Issue with directional lights on ECDIS display

Background.

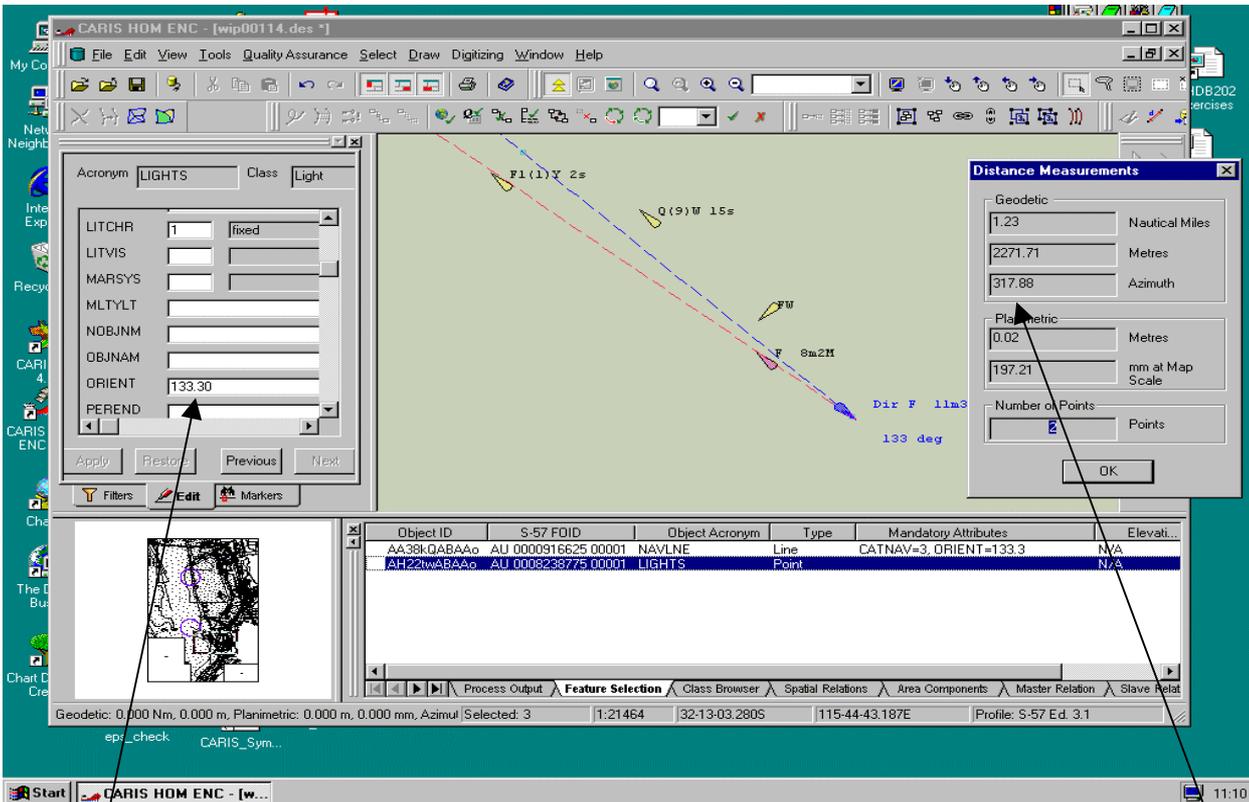
The red line is an S-57 object **NAVLNE** created from a spatial feature in a Transverse Mercator chart.

Its attribute **ORIENT** = 133.3. The bearing also reads 133.3 when queried in CARIS HOM. All appears to be correct.

The blue line is **software generated** based on the attribute **ORIENT** (is also 133.3) of a directional light created as an S-57 object **LIGHTS** (see pop up window above).

The bearing of the blue line when queried in CARIS HOM is 137.88 degrees, not 133.3 degrees. (CARIS display has been used to highlight the issue. Some ECDIS which extend directional lights over long distances also display this issue (a plot will be shown at the actual CSMWG meeting. However when an OEM displays a short line for the directional light, usually in conjunction with other coloured sectors, the discrepancy cannot be seen as the emerging gap widens the further out from the light you go).

The source of the discrepancy is unknown. It may be because the source was a large scale Transverse Mercator paper chart, it could be caused by a mathematical formula

used in the Presentation Library, it may be an OEM issue if they create the bearing of the directional light using their own algorithm, or it may be caused by some OEMs re-projecting the display to a certain projection, rather than leaving the display projectionless. (S-57 datasets are Lat/Long based and projectionless).

Australia believes that the S-52 Presentation Library should be amended to remove the automatic generation of the line representing the bearing of the directional light (shown blue above, but the colour appears to alter between various ECDIS). It also suggests that S-58 (the Recommended ENC Validation Checks) should be amended to provide a WARNING that all directional lights should be associated with a **NAVLNE**. This check is only to be a WARNING, not an ERROR because in Australia and probably other nations as well, we have some directional lights with a very narrow highly intensified sector, which we encode as **CATLIT=1** directional, together with **SECTR1** and **SECRT2** for the narrow intensified sector. In the more common case of directional lights, a **NAVLNE** will be encoded, but NOT in the case of these narrow highly intensified sectors.

In our waterways spontaneously two directional lights cross my mind, one in the approach of Wismar and one in Stralsund. Both have **ORIENT** set to unknown and are defined by **SECTR1** and **SECTR2** as a narrow sector. In the visualisation tools I know, **ENCDesigner**, **ORCAMaster**, **dkartinspector** and **ECPINS** there are no display problems caused by the open **ORIENT** value. For the purpose of testing, I have modified the light **Lieps** by substituting the **SECTR1** and **2** values by **ORIENT**. On all systems (see attachment) the direction of the bearing line is correct. The only difference to Australian cells is that our paper charts, that were used as source, have a simple Mercator Projection and not a Transversal, but that should not make a difference. My assumption is that the display at the CARIS system is erroneous.

Therefore I would recommend not to do any changes at all. Particularly I do not see any sense in creating **C_AGGR** objects between **NAVLNE** and **LIGHTS** especially because we principally do not create such objects.

So BSH could not detect this issue with the software they have available. From Australia's observations, it appears to be a display issue for both CARIS and the S-52 Presentation Library. As the 'line' of the directional light is not selectable on ECDIS, a simple solution may be to not symbolise directional lights with the bearing line. This issue was discussed at C&S14 and the concern was that HOs were not trusted to encode the navigational line for directional lights and that the PL would continue to generate the line automatically (C&S14 Minutes, section 12.4). The paper C&S14-12D was from Mike Eaton to C&S14 meeting. It mentions only a clutter issue but in fact (as can be seen from the above graphic), it is a mis-alignment of the bearings issue, which is far more serious. Perhaps there is something wrong with the software that automatically generates the bearing line on the ECDIS?

CARIS has suggested that S-58 be updated to include a check that all **LIGHTS** with a **CATLIT=1**, must have a **NAVLNE** associated with it. This is the same suggestion that Richard Carpenter came up with at the C&S14 meeting (see Minutes). But note there is now an issue with narrow highly intensified sectors (see background information above). As S-58 is in review, and is not within the S-57 'freeze', it may be possible to update it, which in turn would allow the CSMWG to remove the section of the CSP that automatically generates the bearing for directional lights.

At first look, I think that it is reasonable to add this to S-58. In fact, since the S-57 UOC 12.8.6.5 Directional lights states "The recommended track must be encoded by the method described in clause 10.1" (clause 10.1 is Leading, clearing and transit lines and recommended tracks). I'm surprised that there isn't already a check due to the 'must.' In order for the test to work, the line(s) and the light must be aggregated, which is already required under UOC 10.1.2 and tested by 1682. I would suggest that an encoding bulleting might also be produced to emphasize that if these rules are not followed, an ECDIS will not display the recommended track (assuming that the symbolization based on the light is removed from the PL).

Looking at the existing test 1756 in S-58, I wonder exactly how it is implemented in testing software. It isn't clear to me that the test requires an **ORIENT** value for a directional light; however test 507 does check for mandatory attributes and **ORIENT** is mandatory for directional **LIGHTS**. What would the effect be of encoding the **ORIENT** as unknown (i.e., null) on the light? Does that result in a '?' on the display? If not, could the issue be solved with an Encoding Bulletin that points out the problem with the solution of an 'unknown' **ORIENT** on the **LIGHTS** and a mandatory recommended track? This would then be an encoding fix with no PL change required.
